EXHIBIT D

**Sherry Jordan
Senior Planner, City of Culver City
Community Development Department, Planning Division
9770 Culver Boulevard
Culver City, California 90232**

**Ref: Technical Memo for the Third Party Review of the Visual Simulations prepared for the
Entrada Office Tower Project**

View Location 8

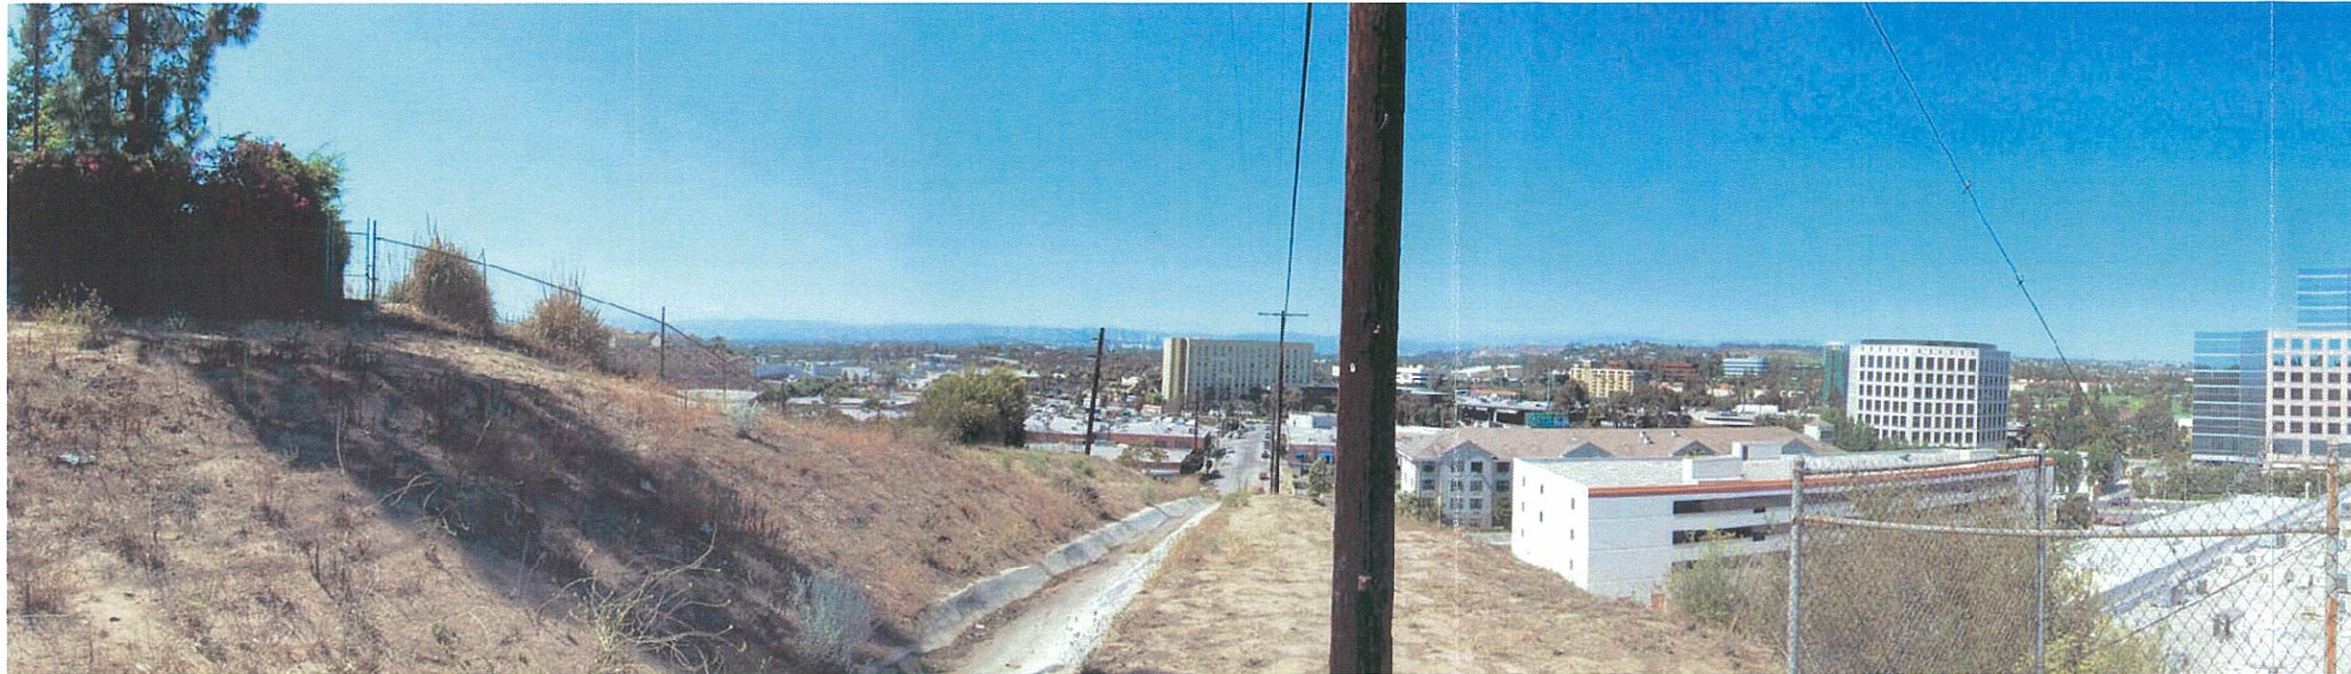
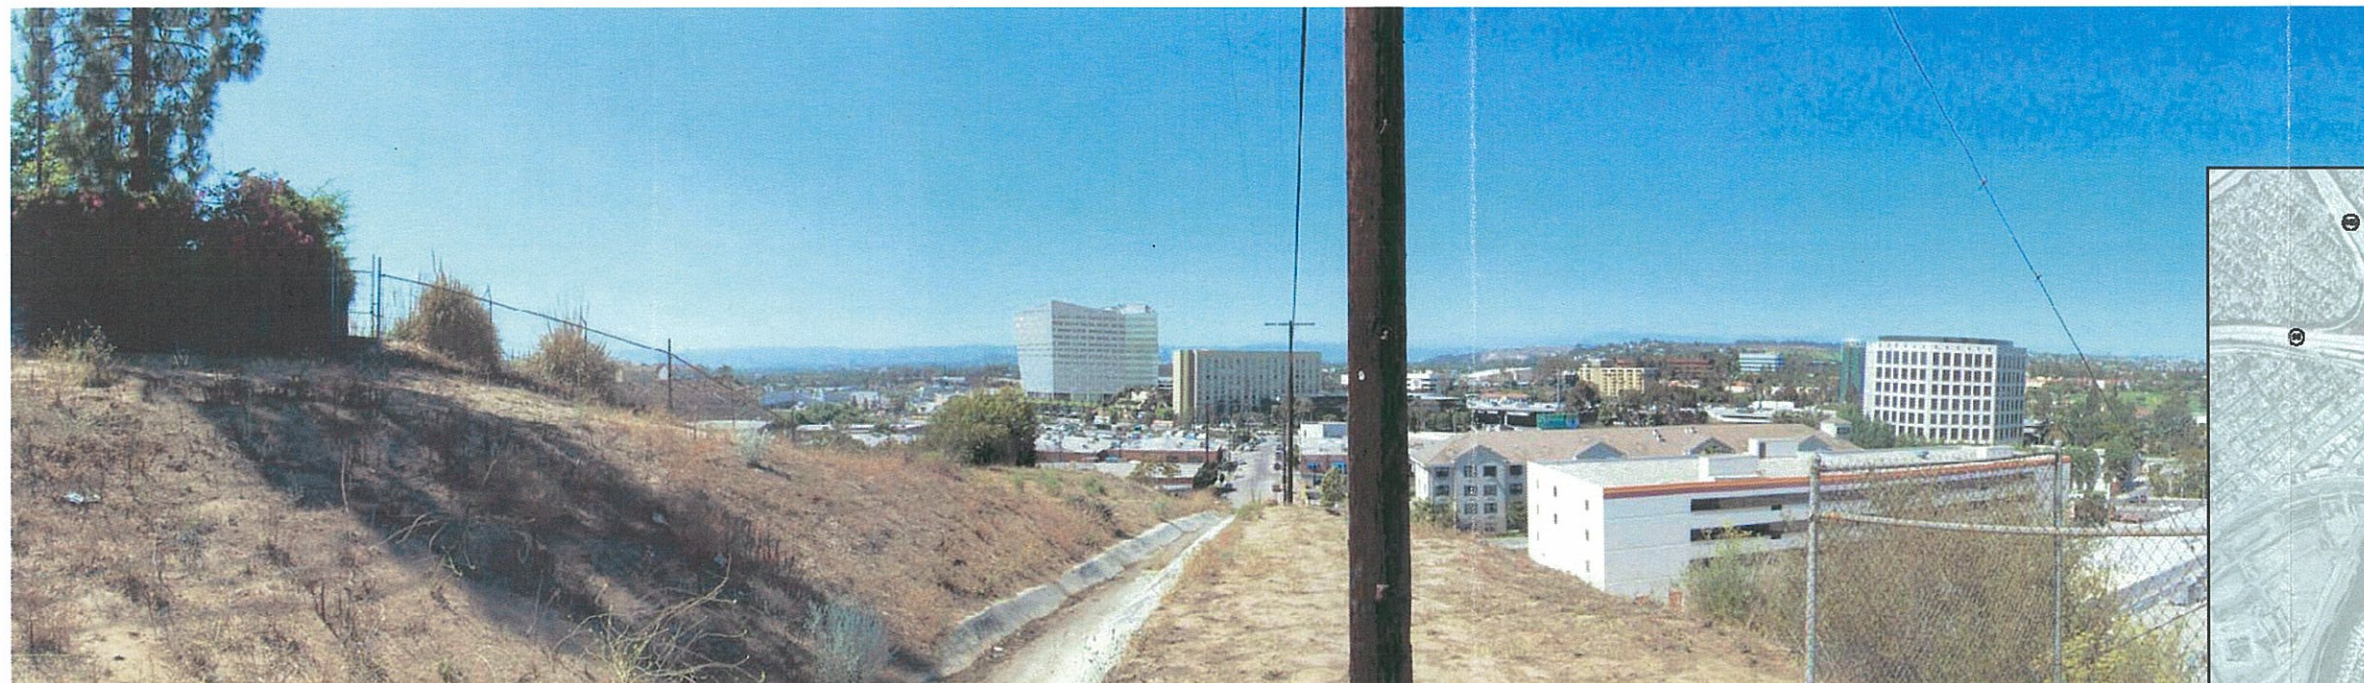
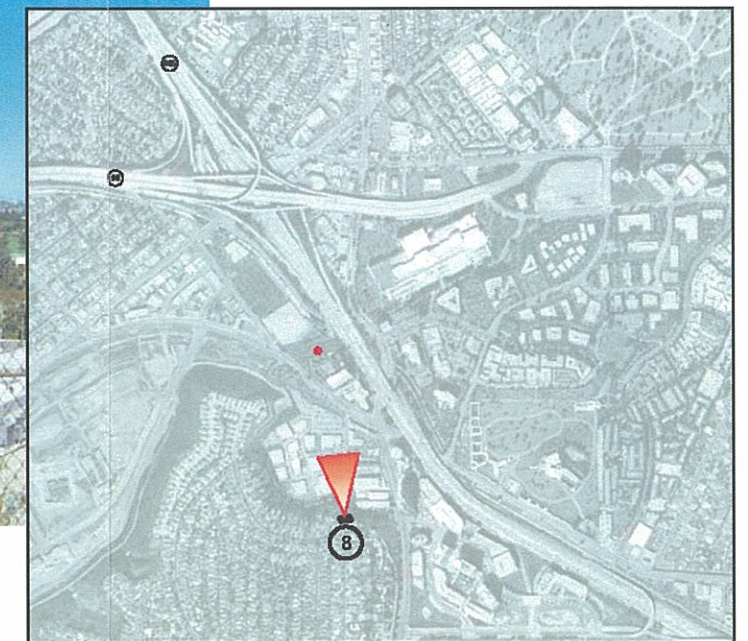
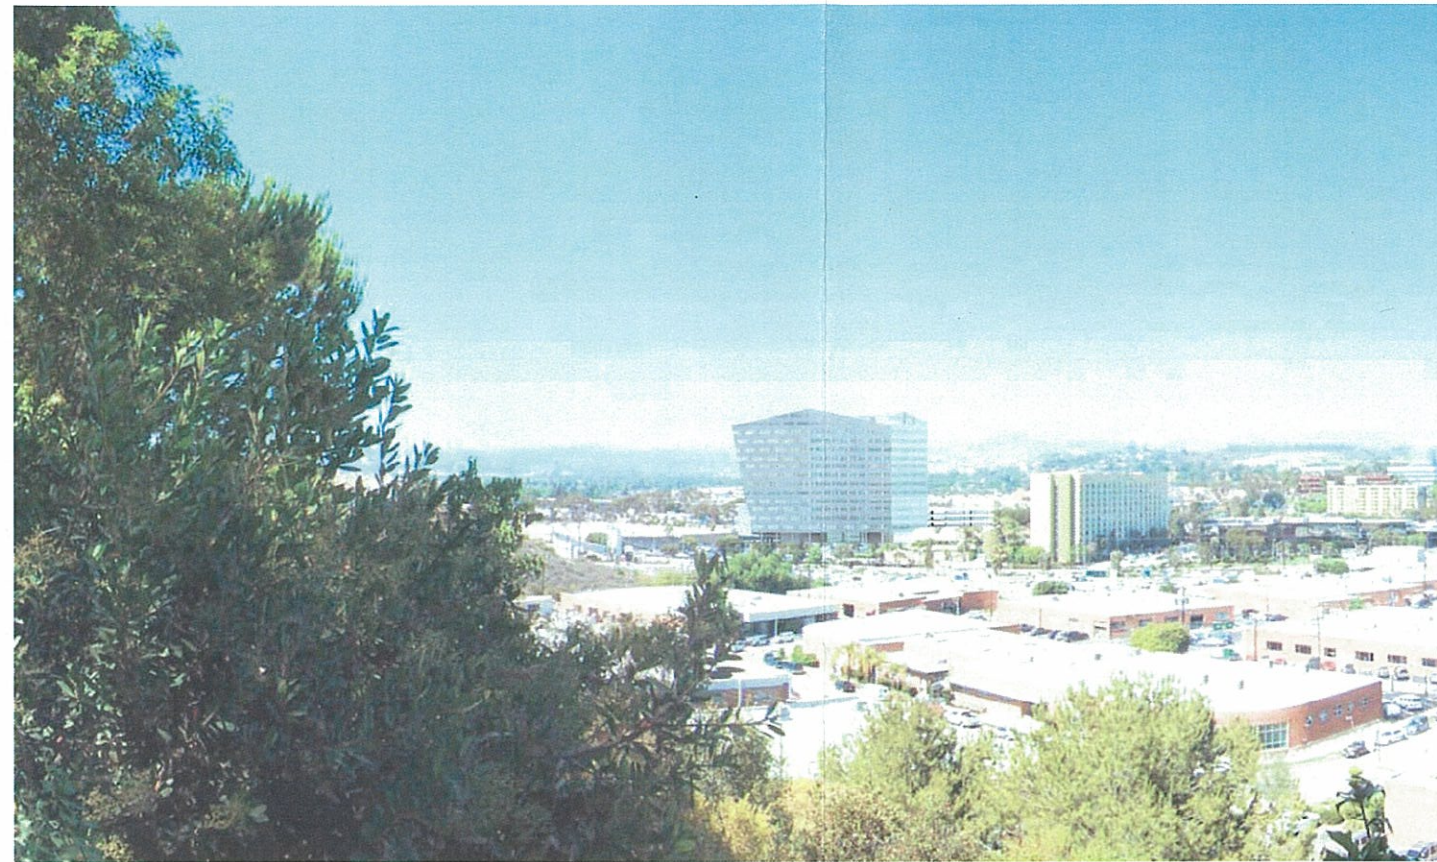
Keyview #8: (Direct and Panoramic): Adjusted by Gensler for Radisson height change (114.5'); reviewed by KTU+A and found that some geometry of horizontal level, rotation, scale and position needed to be adjusted. Gensler corrected and returned to KTU+A and was found to match with KTU+A models. Visual Simulation #8 now confirmed by KTU+A to be reasonably accurate based on the KTU+A model and keyview location assumptions.

Keyview #8: (Normal 50mm): New photograph taken by KTU+A on site with tripod level, GPS coordinates and a lens that would produce a field of view similar to what a normal 50mm uncorrected lens would produce. Visual Simulation #8 supplemented by an additional simulation produced by KTU+A to closer replicate the scale and positioning of what the focused human eye would typically see (not counting expanded view and peripheral vision).

View Location 9

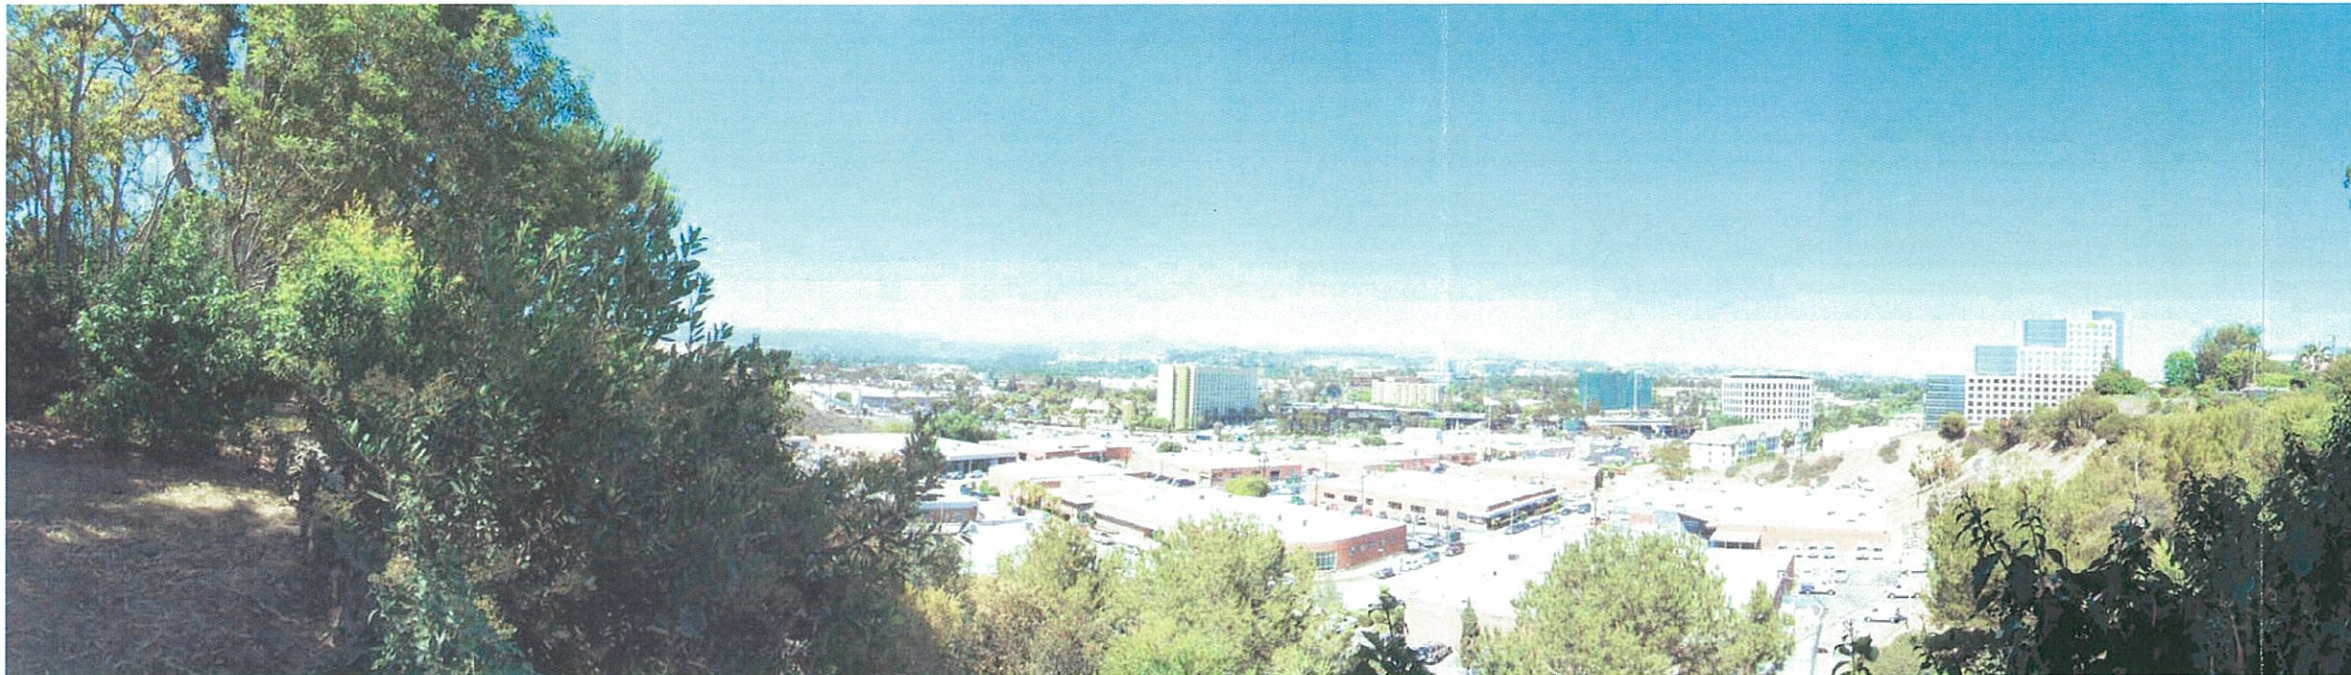
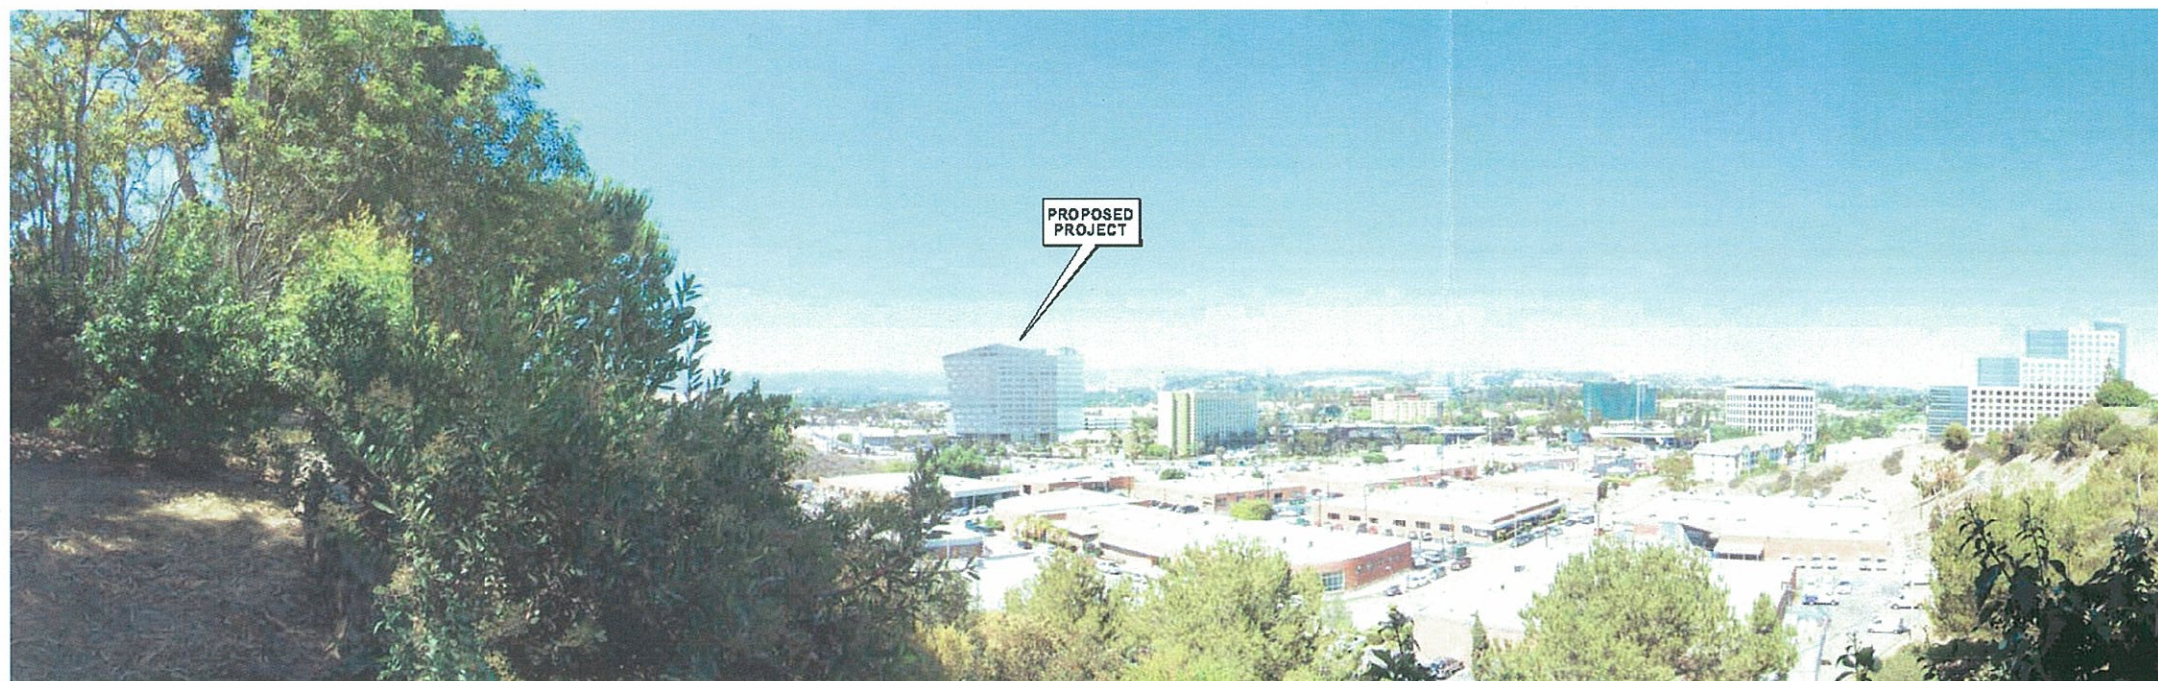
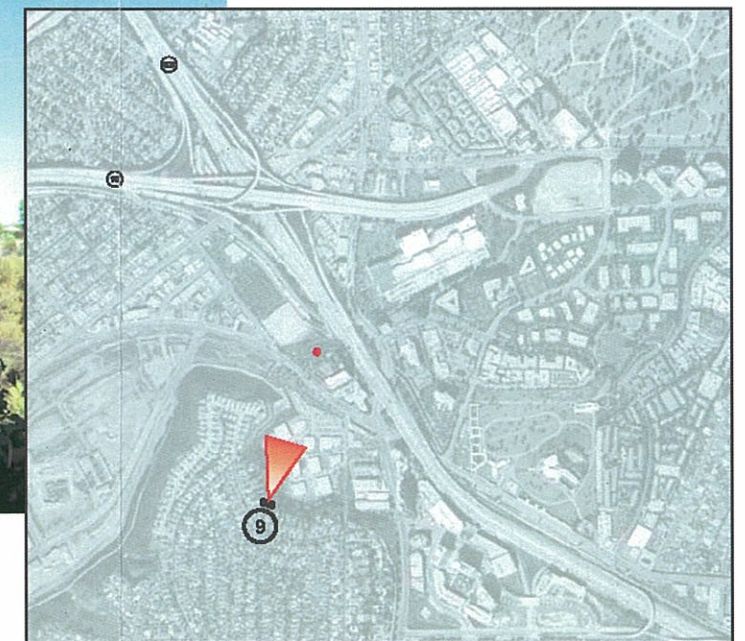
Keyview #9: Adjusted by Gensler for Radisson height change (114.5'); reviewed by KTU+A and found that some geometry of scale and position needed to be adjusted, Gensler corrected and returned to KTU+A and was found to match with KTU+A models. Visual Simulation #9 now confirmed by KTU+A to be reasonably accurate based on the KTU+A model and keyview location assumptions.

Keyview #9: (Normal 50mm): New photograph taken by KTU+A on site with tripod level, GPS coordinates and a lens that would produce a field of view similar to what a normal 50mm uncorrected lens would produce. Visual Simulation #9 supplemented by an additional simulation produced by KTU+A to closer replicate the scale and positioning of what the focused human eye would typically see (not counting expanded view and peripheral vision).
